UNITED STATES PATENT AND TRADEMARK OFFICE

APPLICATION NO.	FILING DATE	FIRST NAMED INVENTOR	ATTORNEY DOCKET NO.	CONFIRMATION NO.
10/783,479	02/20/2004	Larry D. Morris	2810	2140
36288	7590	08/31/2004	EXAMINER	
KENNETH H. JACK 2121 MAPLE WICHITA, KS 67213			KOVACS, ARPAD F	
			ART UNIT	PAPER NUMBER
			3671

DETAILED ACTION

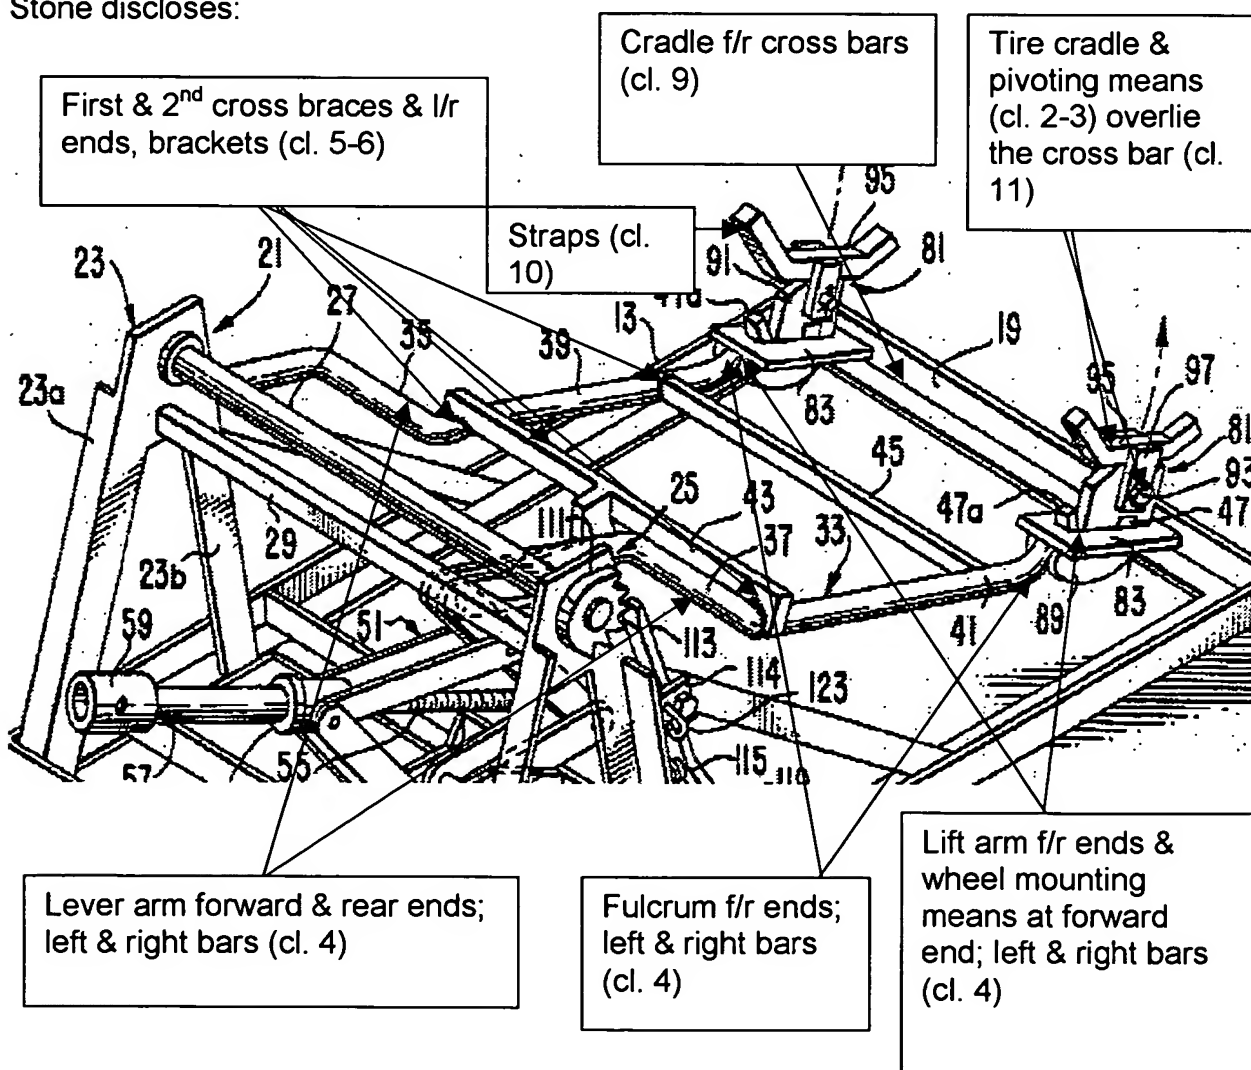
3. Claims 1-6 are rejected under 35 U.S.C. 102(b) as being anticipated by Stone (4549721, cited by Applicant).

Stone discloses:
